Monitoring Report – Year 4  
FINAL VERSION  
Edwards-Johnson Mitigation Project  
Calendar Year of Data Collection: 2021

NCDEQ DMS Project Identification # 97080  
NCDEQ DMS Contract # 6825  
Neuse River Basin (Cataloging Unit 03020201)  
USACE Action ID Number: SAW-2016-00883  
NCDEQ DWR Project # 2016-0404 V2  
Johnston County, NC  
Contracted Under RFP # 16-006477  
Data Collection Period: September 2021  
Submission Date: October 20<sup>th</sup>, 2021

**RE: WLS Responses to NCDEQ DMS Review Comments for Task 10 Draft Monitoring Report Year 4 for the Edwards-Johnson Mitigation Project, NCDEQ DMS Full-Delivery Project ID #97080, Contract #006825, Neuse River Basin, Cataloging Unit 03020201, Johnston County, NC**

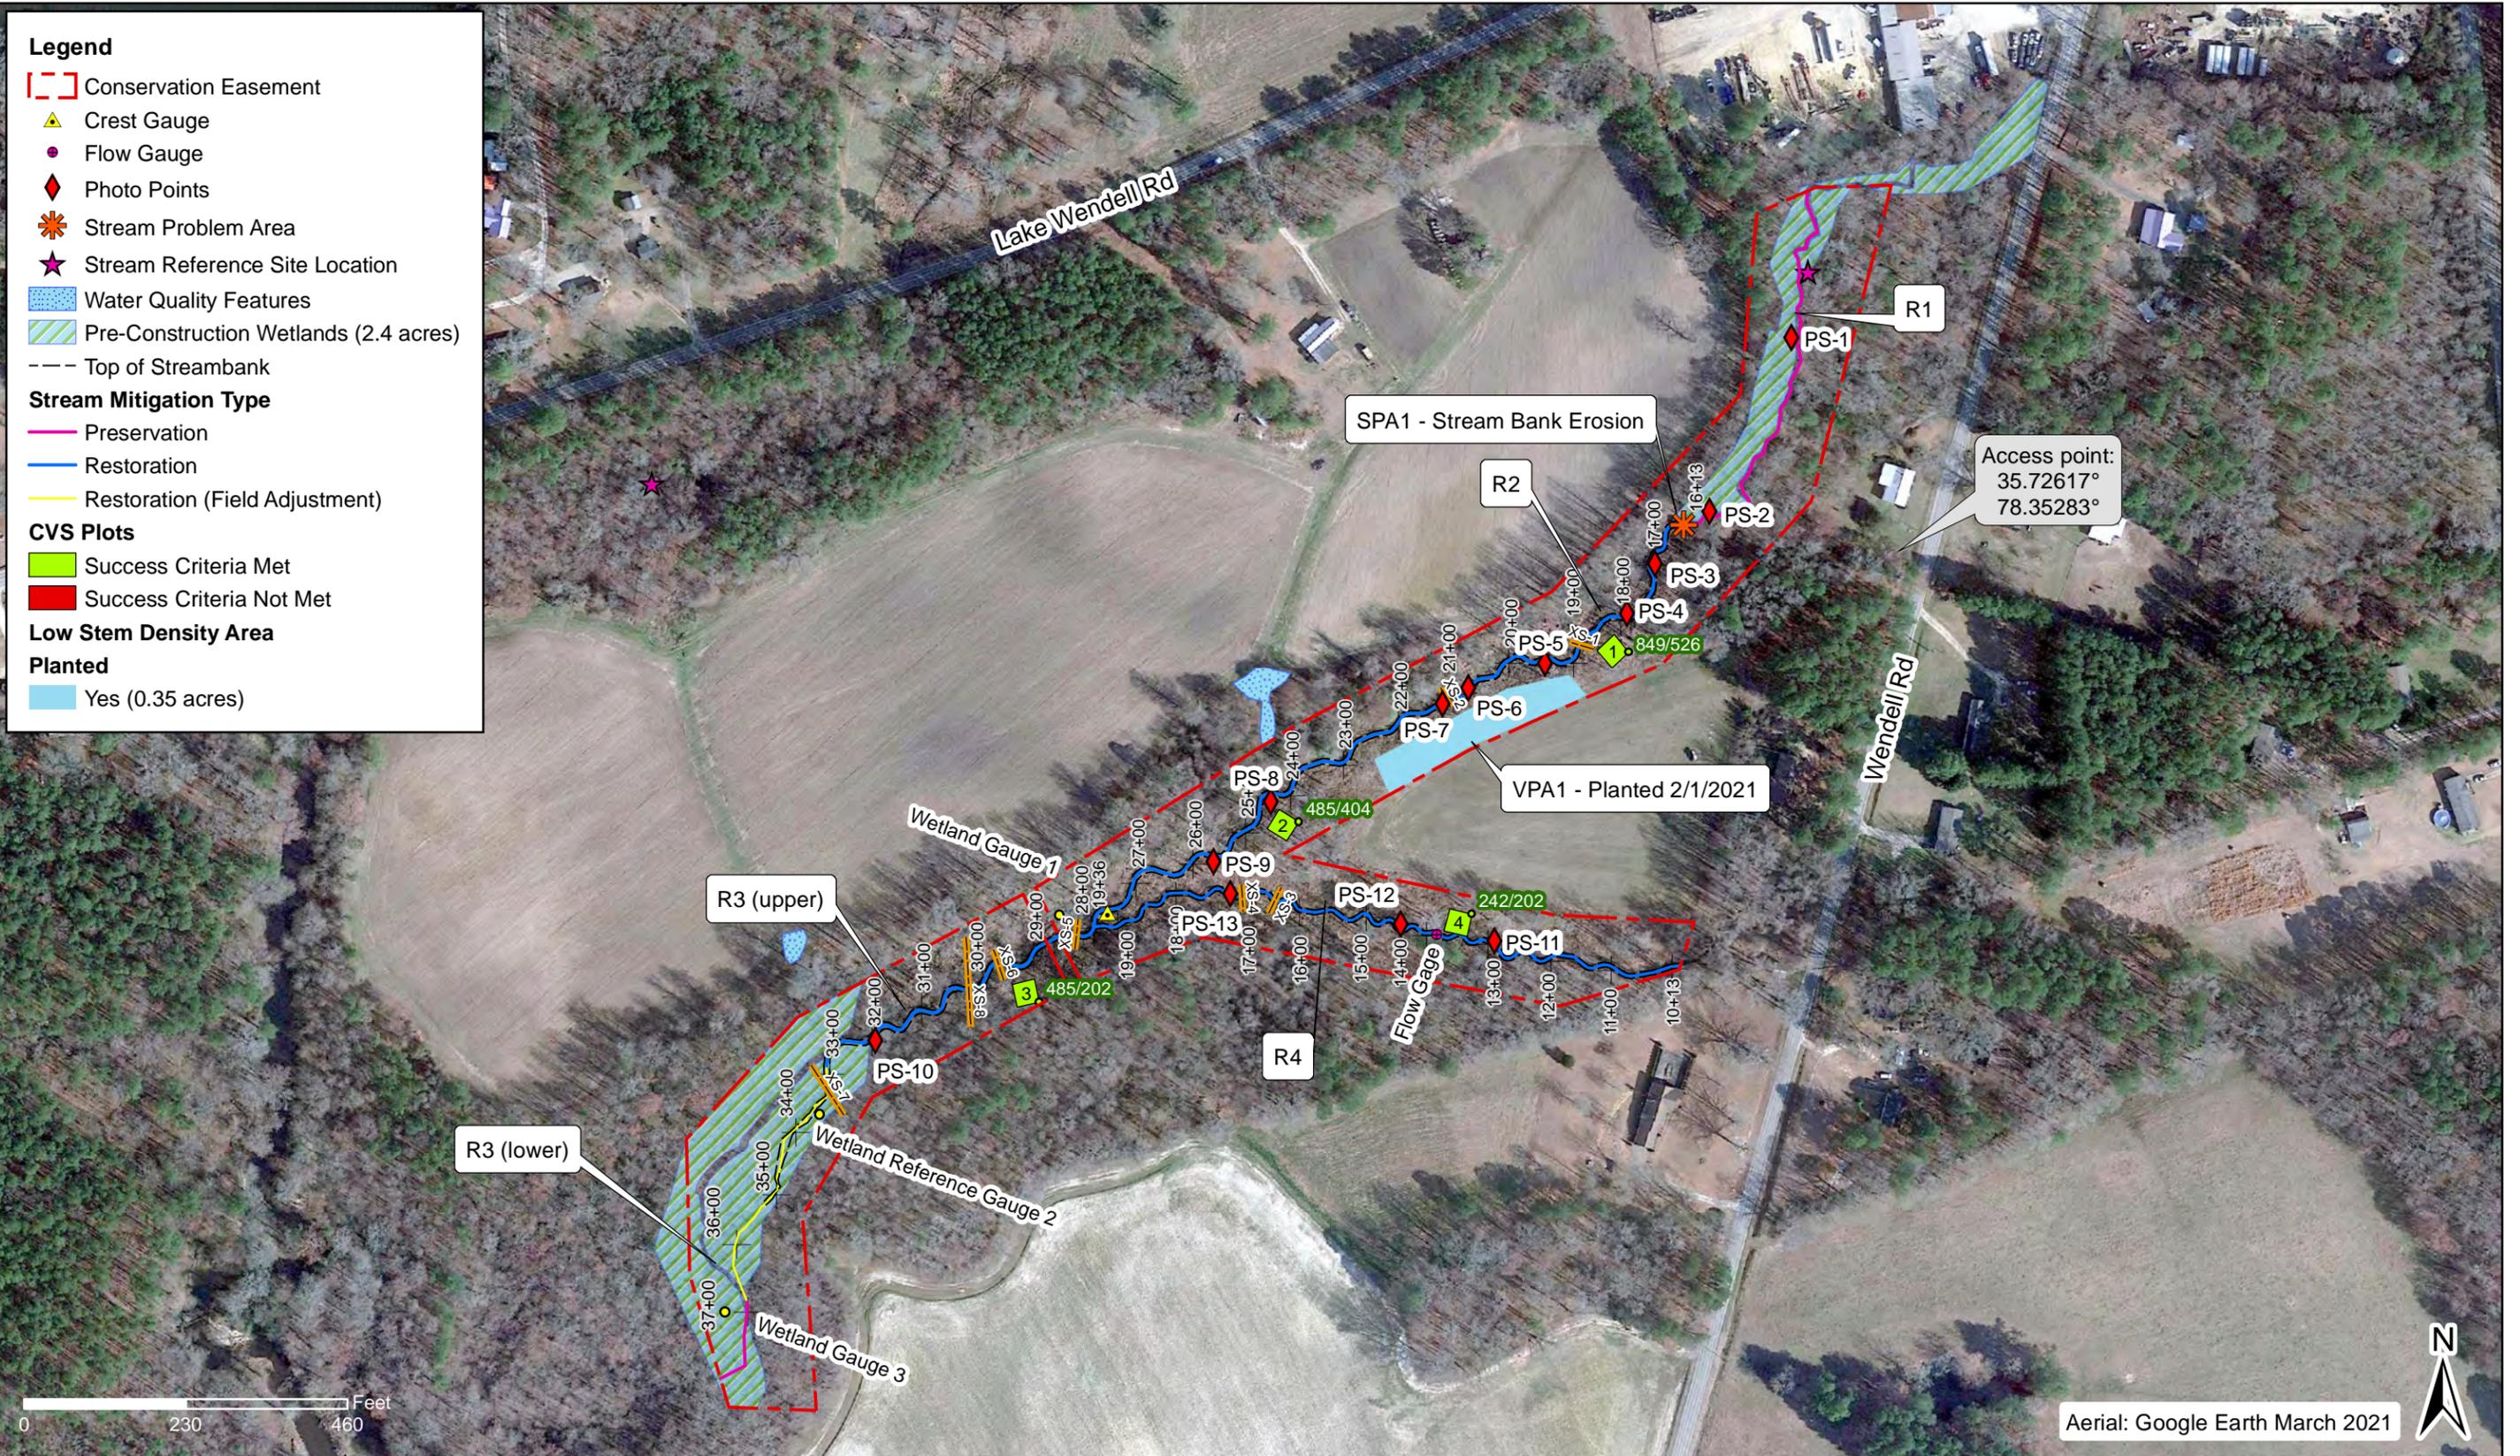
- 2. DMS Comment: Clarify on the Legend for the Encroachment area (0.04 acres) to show planting year or remove shapefile because there were also replanted areas in previous monitoring years that are not shown (because this is considered no longer an encroachment).** WLS Response: The encroachment area was replanted in 2019 and is no longer an encroachment. The encroachment was removed from the CCPV.

**Figure 5: Monthly Rainfall Data**  
**Edwards-Johnson Mitigation Project (NCDEQ DMS Project ID# 97080)**  
**MY4 2021**

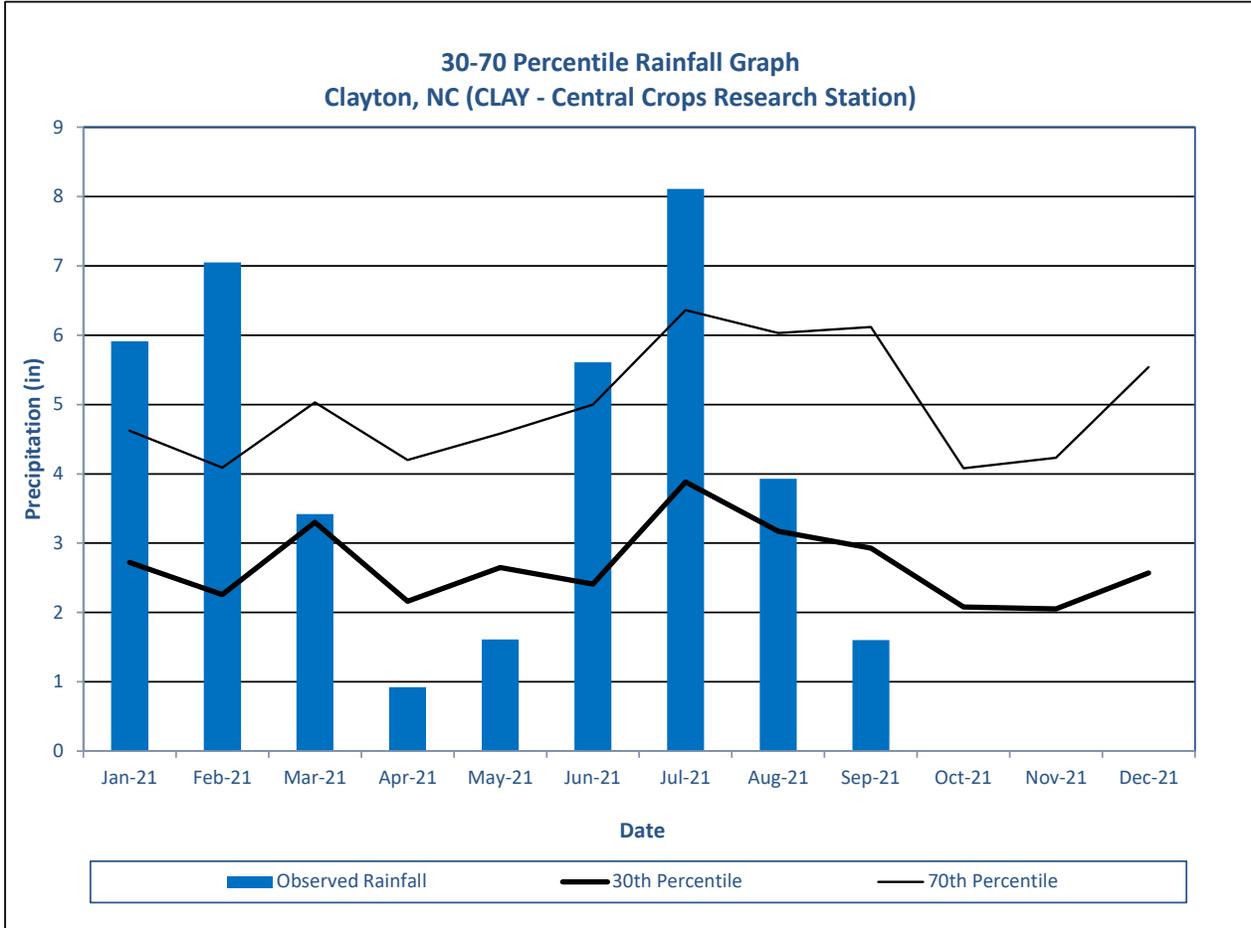
- 5. DMS Comment: Update rain report for additional months if possible.** WLS Response: September rain data has been added to Figure 5.
